Change Order #2

Regional Linear Park Phase II
(Hike & Bike Trail)

Project: RLPPII
Contract: C-18-199-02-12
CSJ: 0921-02-409
Limits: Hall Acres to Ridge Road

Change Order #2 introduces additional cost and work to re-establish drainage on Cage Blvd. (US 281) after installing a 12x8 pedestrian tunnel for this project.

CO #2 Quantities

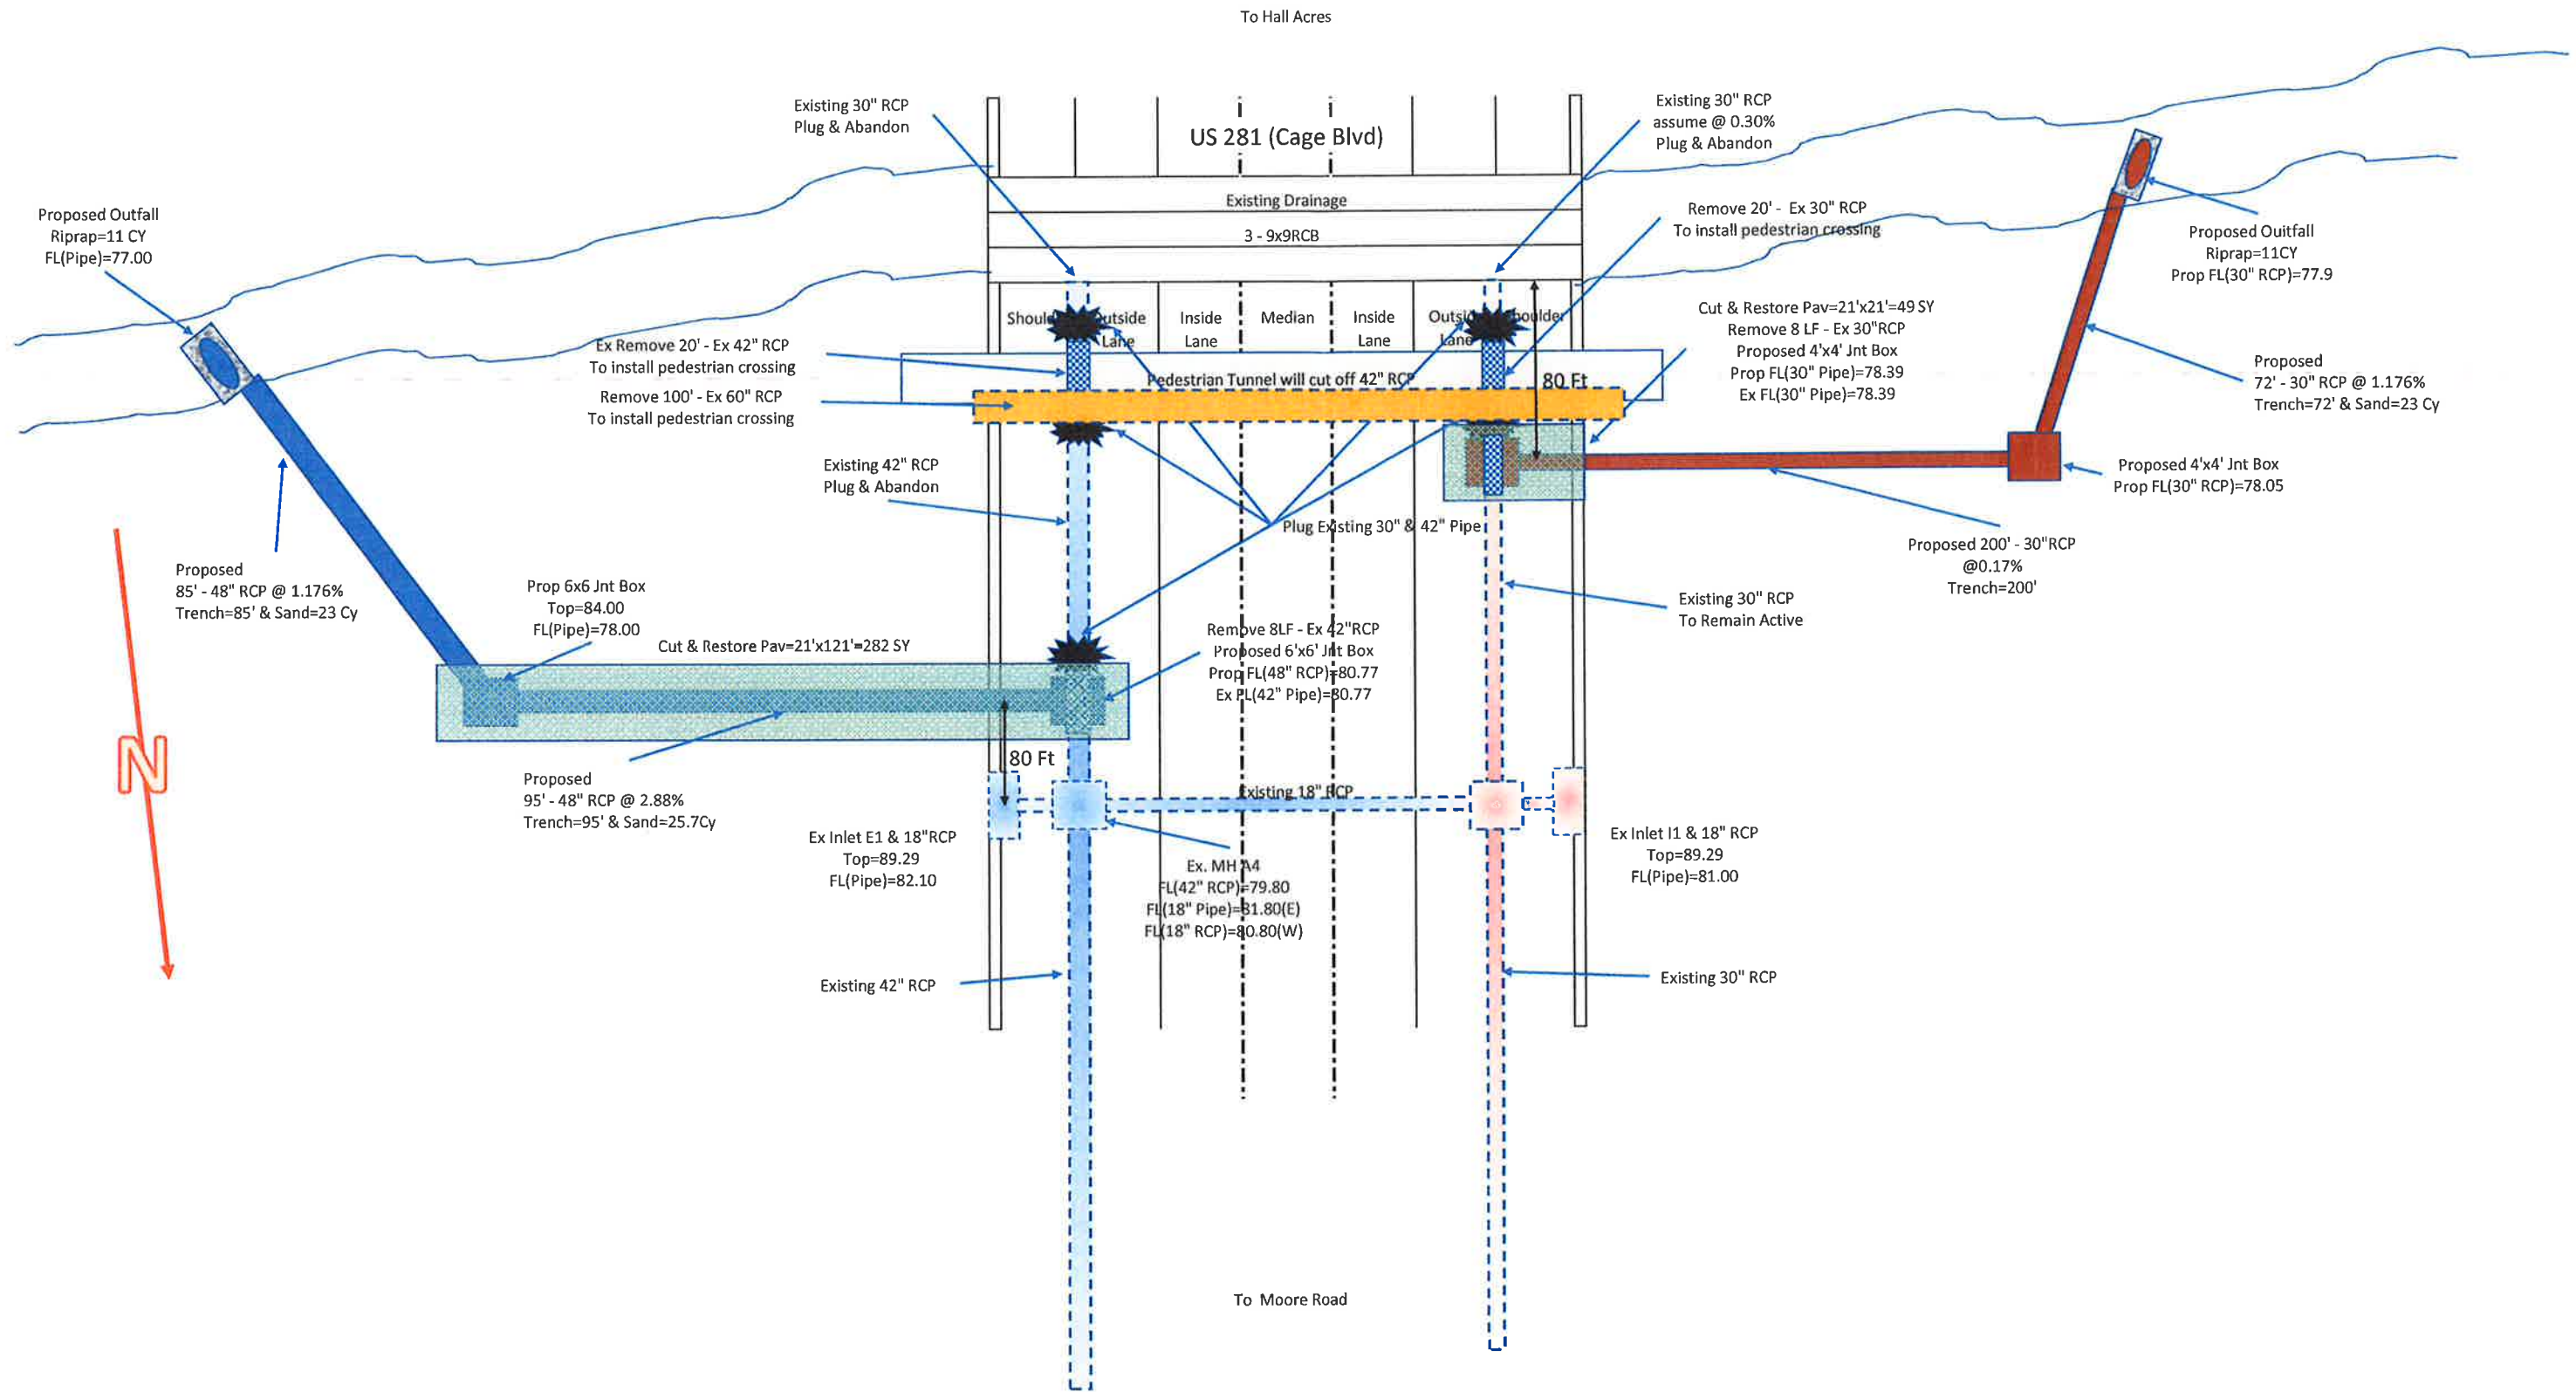
| Item | 0.271cy/Lf | | | | | | | | | 0.111cy/Lf | | | | | | | | | Plug Ea | Cut & Rest * | |
|--|------------|----------------|---------------|-------------|-----------|-----------------|-----------------|-----------------|------------|---------------|-------------|------------|---------------|-------------|----------------|----------------|---------------------|----------------------------|----------|--------------|--------------|
| Remove 18"RCP & Jnt Boxes (Plan Sht 58) No longer required, replaced by 30" Line above | | | | | | | | | | | | | | | | | | | | | |

Pedestrian Tunnel will cut off 42" RCP

Ex Remove 20' - Ex 42" RCP
To install pedestrian crossing
Remove 100' - Ex 60" RCP
To install pedestrian crossing

Existing 30" RCP
assume @ 0.30%
Plug & Abandon

Proposed
85' - 48" RCP @ 1.176%
Trench=85' & Sand=23 Cy

Prop 6x6 Jnt Box
Top=84.00
FL(Pipe)=78.00

Proposed 200' - 30" RCP
@0.17%
Trench=200'

Proposed
72' - 30" RCP @ 1.176%
Trench=72' & Sand=23 Cy
